CHISHOLM CREEK 2ND ADDITION
WICHITA, SEDGWICK COUNTY, KANSAS

RE: S/D 00-13 -- Final Plat of CHISHOLM CREEK 2ND ADDITION

RE: S/D 00-13 -- Final Plat of CHISHOLM CREEK 2ND ADDITION

CASE NUMBER: S/D 00-13 -- CHISHOLM CREEK 2ND ADDITION

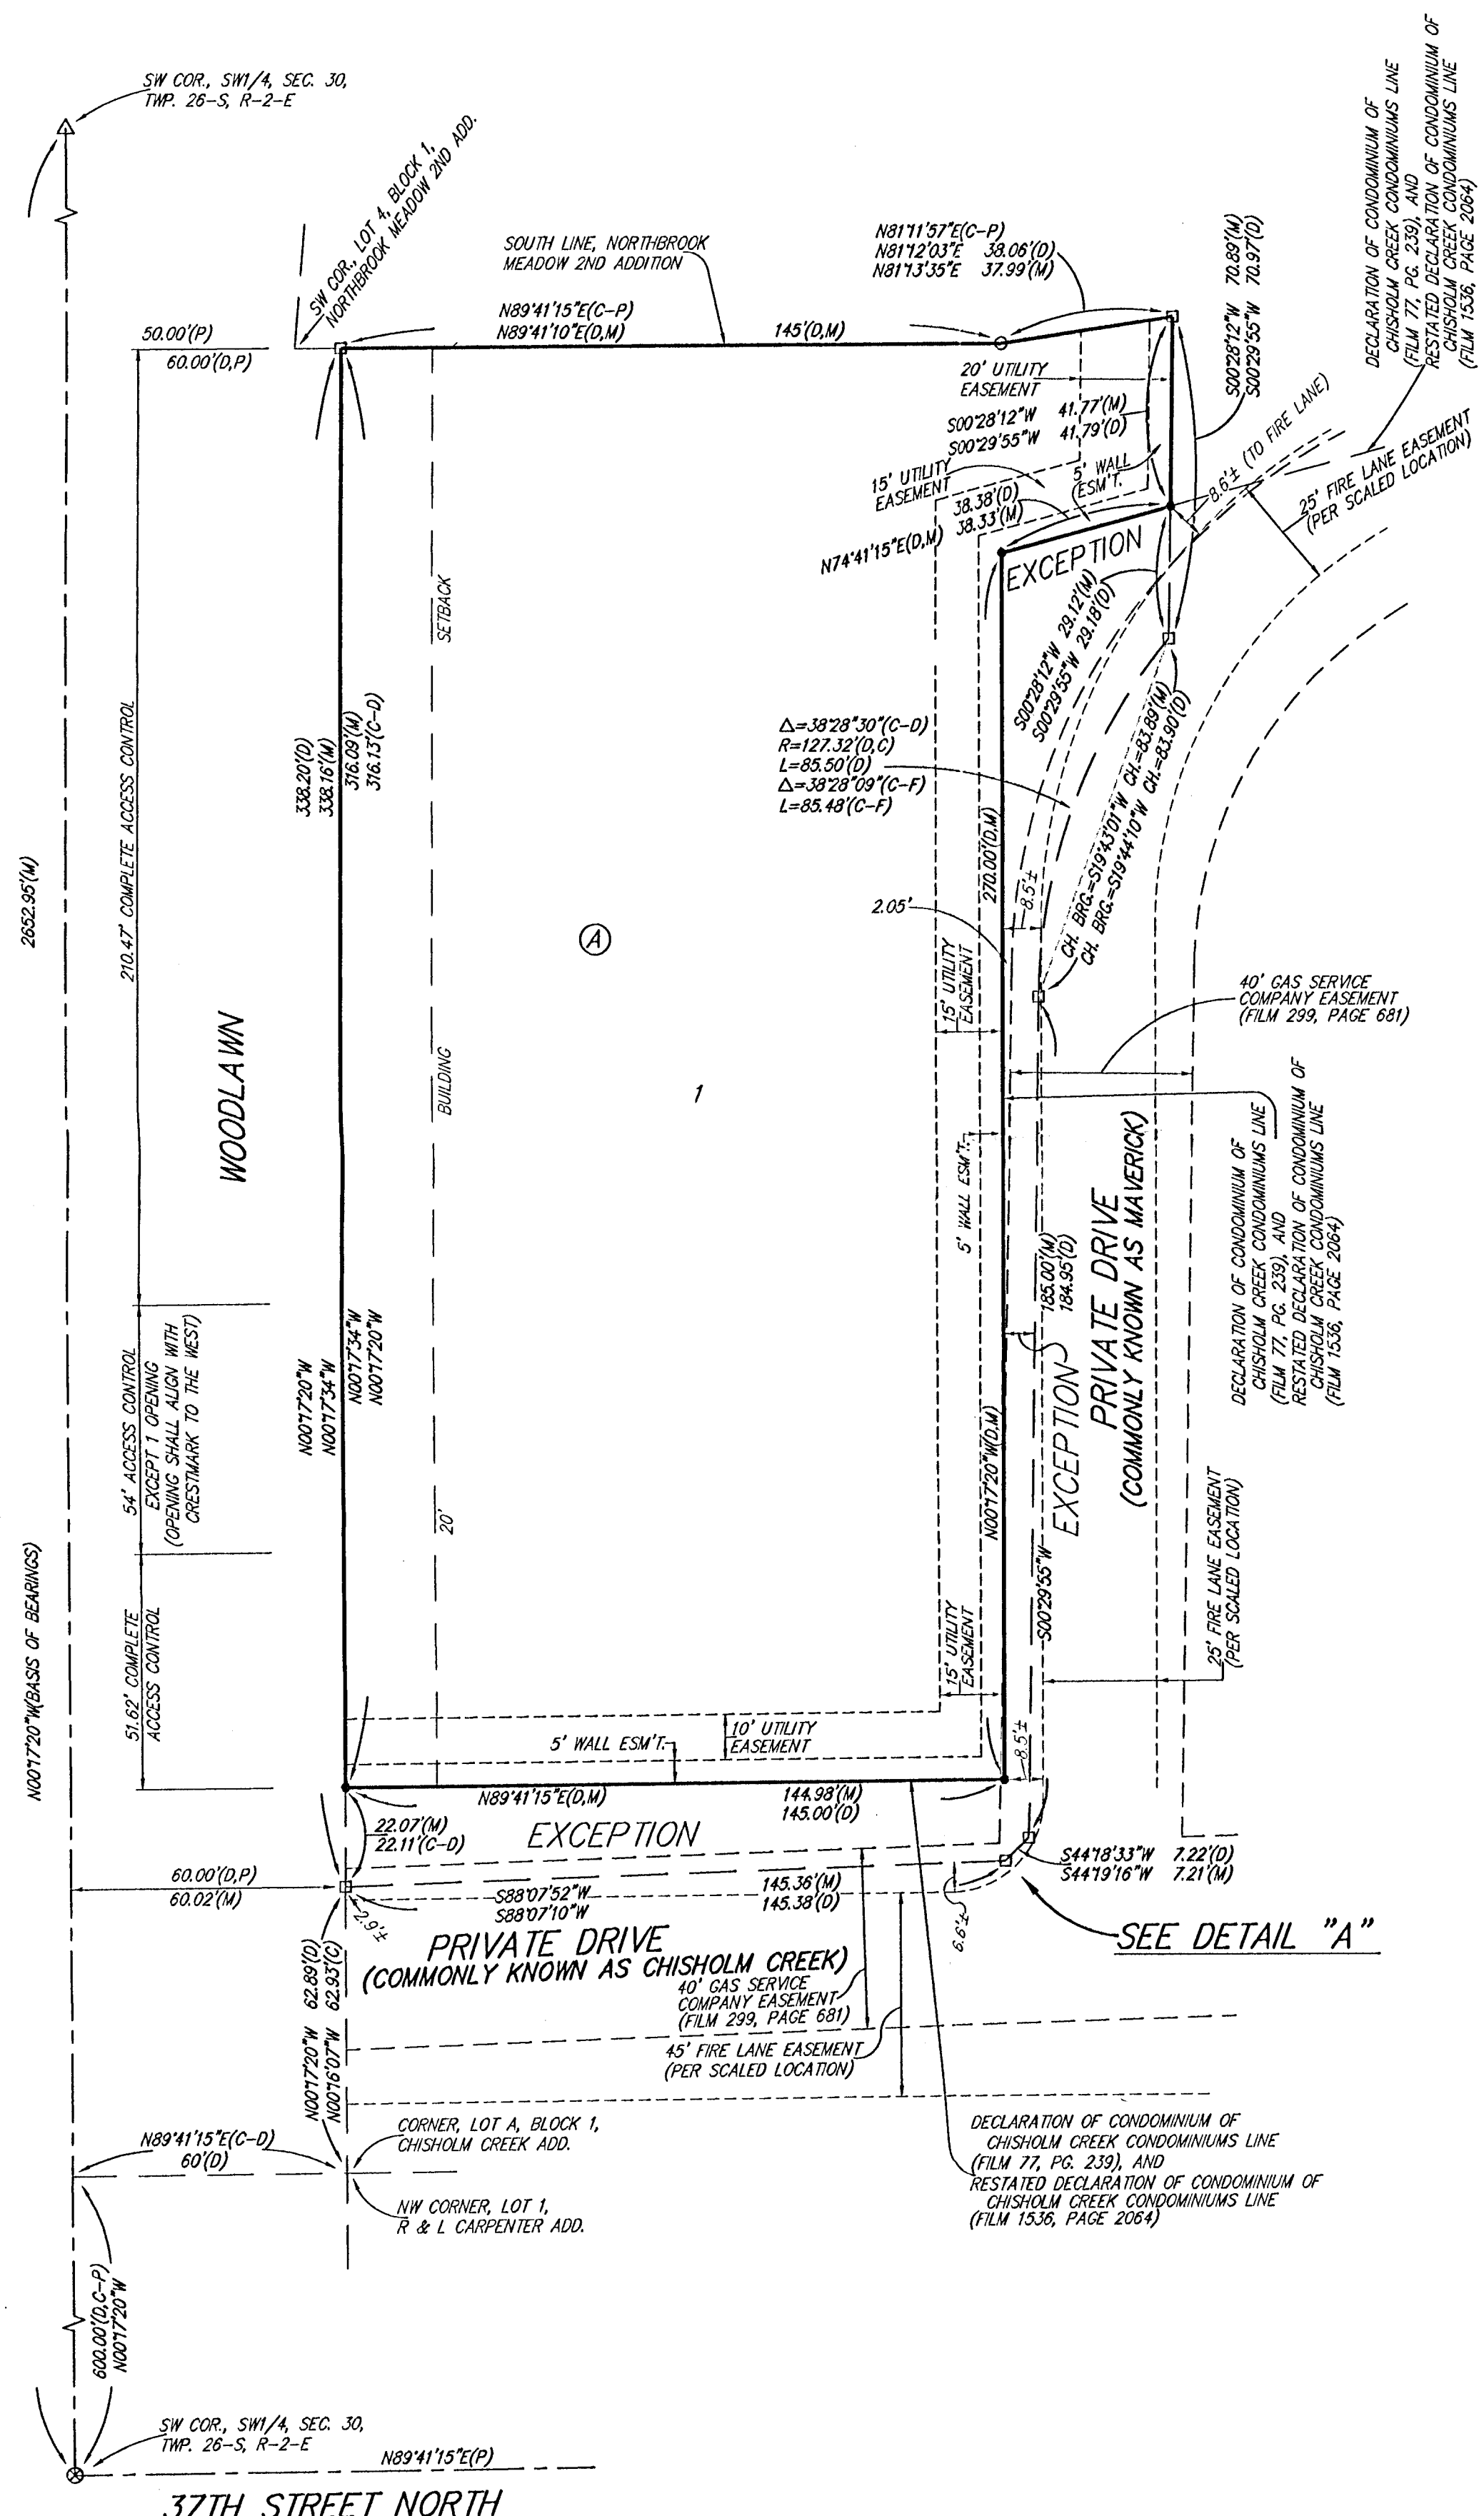
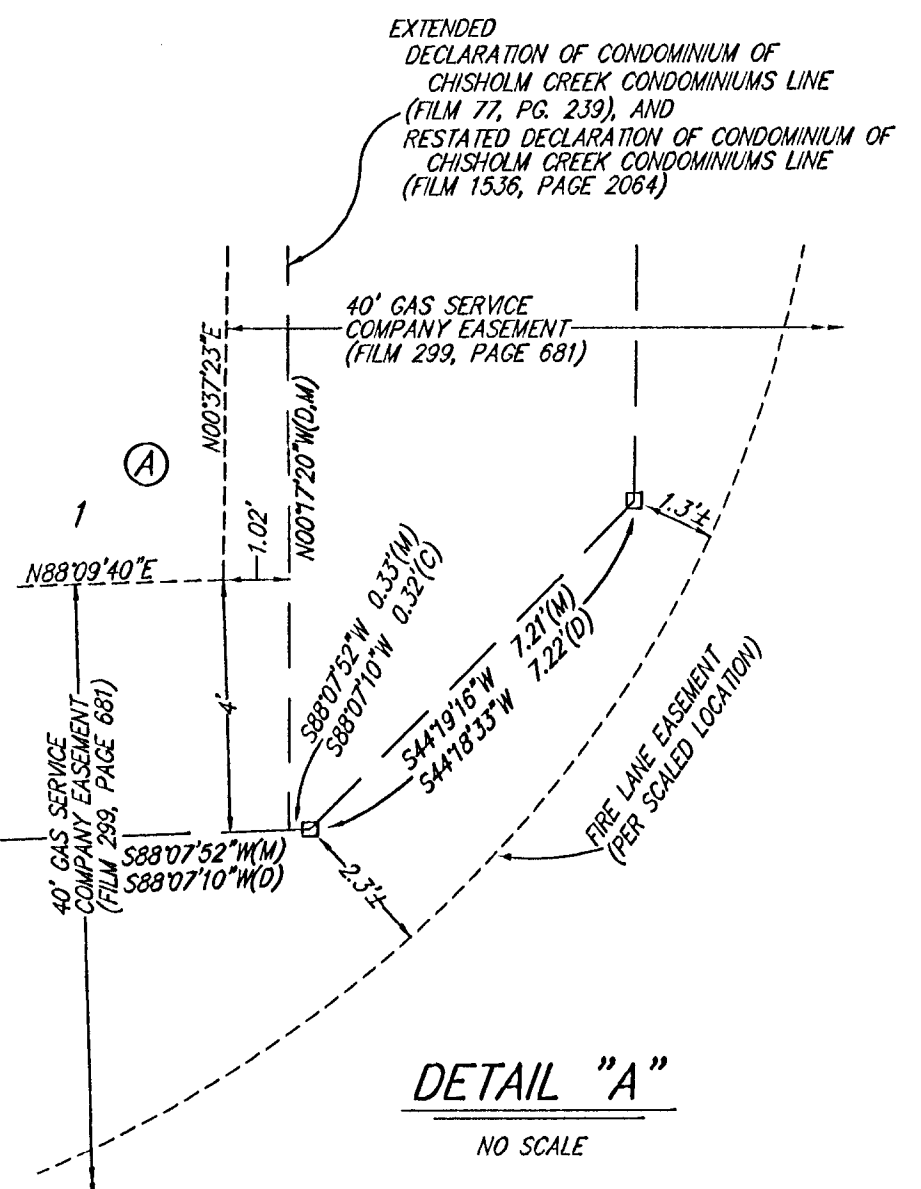
- E. The described distance and bearing for the southeastern property line as referenced in the legal description of the plat's text needs to be included on the face of the plat.

- F. It is recommended that the utility easements be set back from the south and east property lines appropriately to protect existing tree rows.

- H. The Fire Lane easement and the Declaration of Condominium Line needs sufficient ties to locate it definitely with respect to the subdivision.
- I. The following note needs to be removed under the Bench Mark: "Note: Minimum building pad elevation requirements will be established on the final plat."

- J. The plat's text shall include language that a drainage plan has been developed for the plat and that all drainage easements, rights-of-way, or reserves shall remain at established grades or as modified with the approval of the applicable City or County Engineer, and unobstructed to allow for the conveyance of stormwater.

As requested, the Applicant has increased the utility easements to 20 feet along the east and south property lines.
